**DESIGN REVIEW/CERTIFICATE OF APPROPRIATENESS APPLICATION**

Project/Property Address or Location: <b>Lot #9-A Science Boulevard</b>		Project Name/Business Name (if applicable): <b>All R Friends</b>		
Parcel ID No.(s)	Current Zoning: <b>L-OCT</b>	Total Acreage: <b>1.0 acre</b>		
Please check all that apply:				
SITE PLAN <input checked="" type="checkbox"/>	LANDSCAPING <input checked="" type="checkbox"/>	BUILDING DESIGN <input checked="" type="checkbox"/>	SIGNAGE <input type="checkbox"/>	DEMOLITION <input type="checkbox"/> <small>only applicable to Code Chapter 1150, Old Gahanna</small>
Additional Information (if applicable):				
<b>APPLICANT INFORMATION (primary contact)</b>				
Name (please do not use a business name): <b>Frank Albanese</b>		Address: <b>5277 Blue Ash Road</b>		
E-Mail: <b>fnaohio@gmail.com</b>		Phone No. <b>614-554-3464</b>		
<b>ATTORNEY/AGENT INFORMATION</b>				
Name: <b>Steve Lampere PE</b>		Address: <b>8205 Smith Calhoun Road</b>		
E-Mail: <b>steve.l@diamondvllc.com</b>		Phone No. <b>614-620-0331</b>

DESIGN REVIEW/ CERTIFICATE OF APPROPRIATENESS

All R Friends  
1.000 Ac. - Science Blvd.

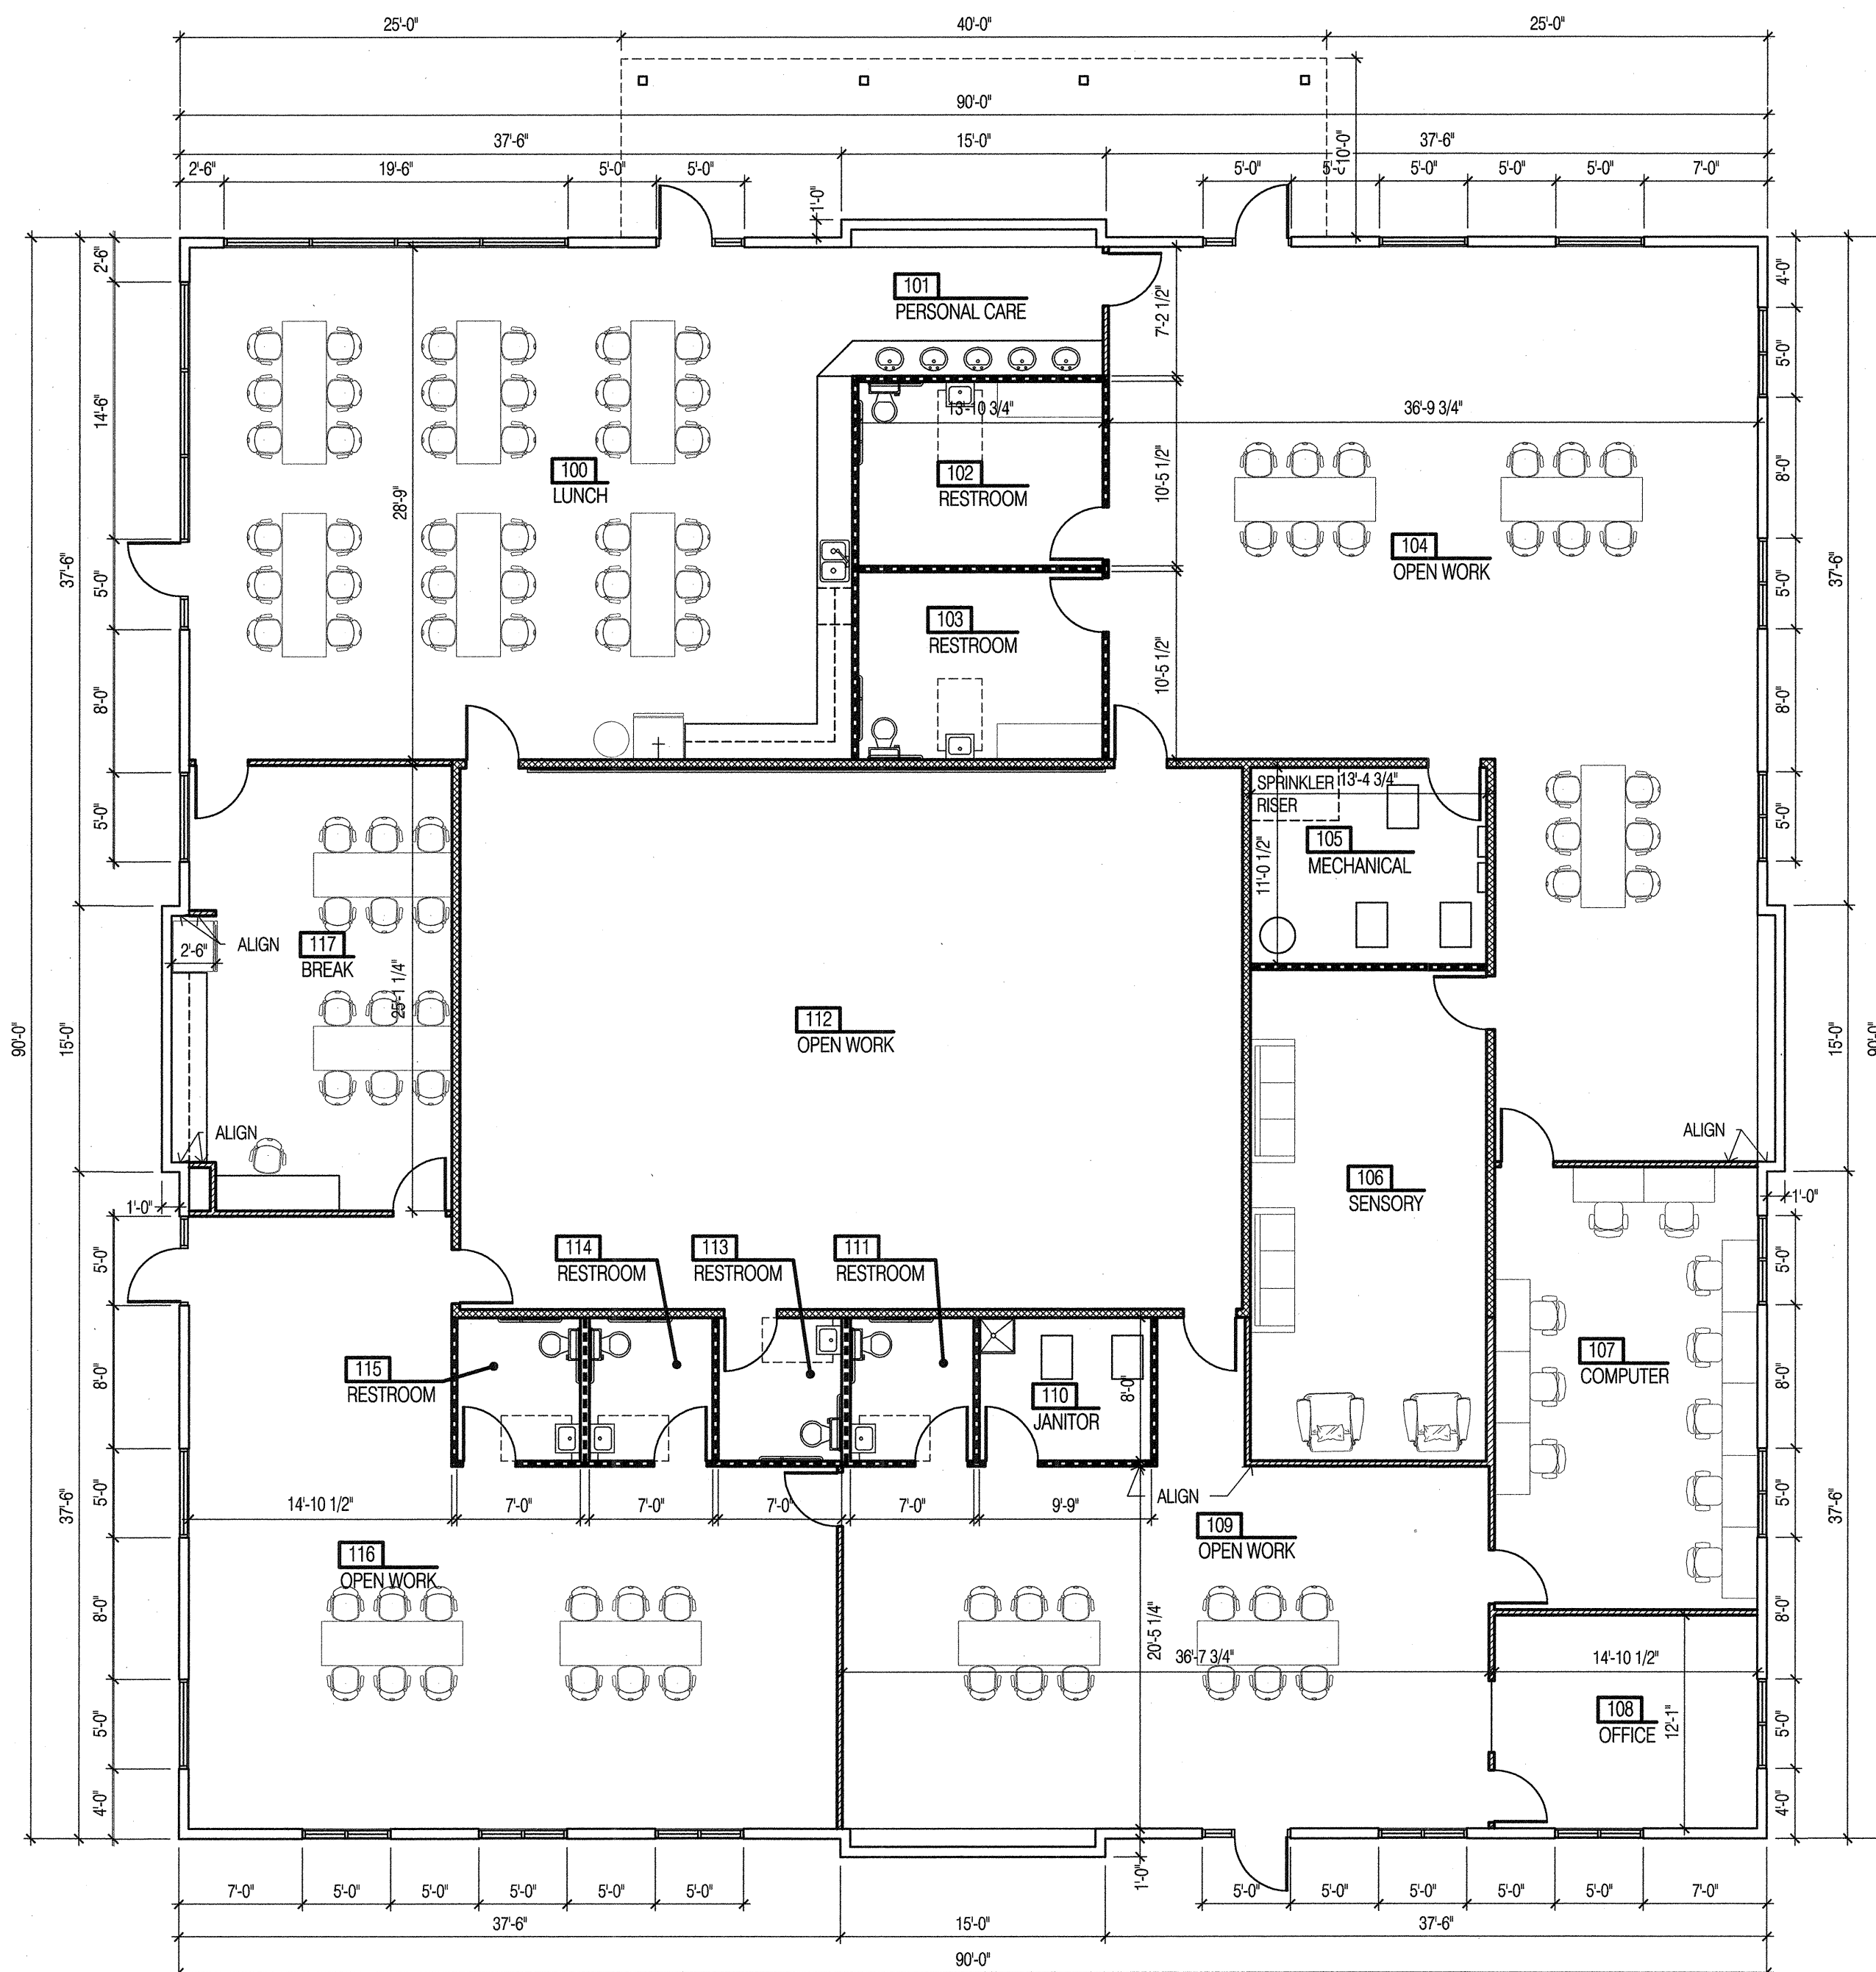
- (d) The request for subdivision is not contrary to platting, subdividing or zoning regulations of the City.
  - **Final Development Plan** – The building proposed for the L-OCT zoned parcel in the Central Park Overlay District is 8,100 sq ft. The required setbacks for this parcel are 10' front, 0' side and 0' rear per the overlay text. 23 parking spaces have been provided, meeting code requirements. The parking setback is 25' from the public ROW, with no side or rear pavement setbacks per the overlay code. There is one point of ingress/egress for the site. Lot coverage is 66%.

- **Design Review** – The exterior finishes consist of light grey stucco, Kentucky limestone, and grey dimensional shingles. The tree planting requirement has been met with the proposed 11 2.5" caliper Pin Oak trees. Each end of the property is screened, with a total of 26 pines.

- A formal final engineering plan review will be required following approval of the Final Development Plan (FDP), or concurrently with the FDP process if requested by the Developer at their risk.
- The FDP shall identify all parking and building setbacks for the parcel.
- Parking lot dimensions shall be provided on the site plan.

Revised Elevation

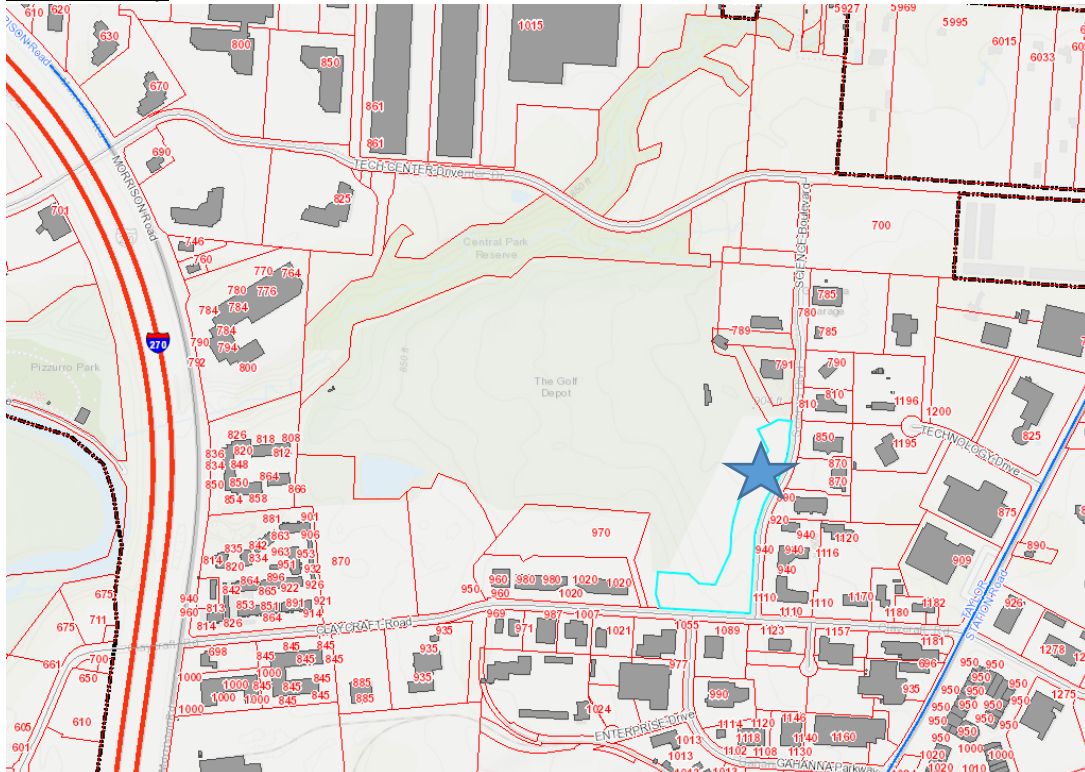
- a) 40%-70% of the main façade for office uses shall be window openings.  
*An updated rendering has been provided. It appears that the main façade (east elevation) meets the aforementioned requirement.*
- b) All buildings shall provide a minimum tree planting within the interior of the site to help provide shade and increase aesthetic value. Trees shall be a minimum of 2" in caliper.  
*An updated site plan has been provided. The tree size, 2 ½", meets the requirements of the overlay.*

*The application as submitted appears to meet the requirements of the overlay.*
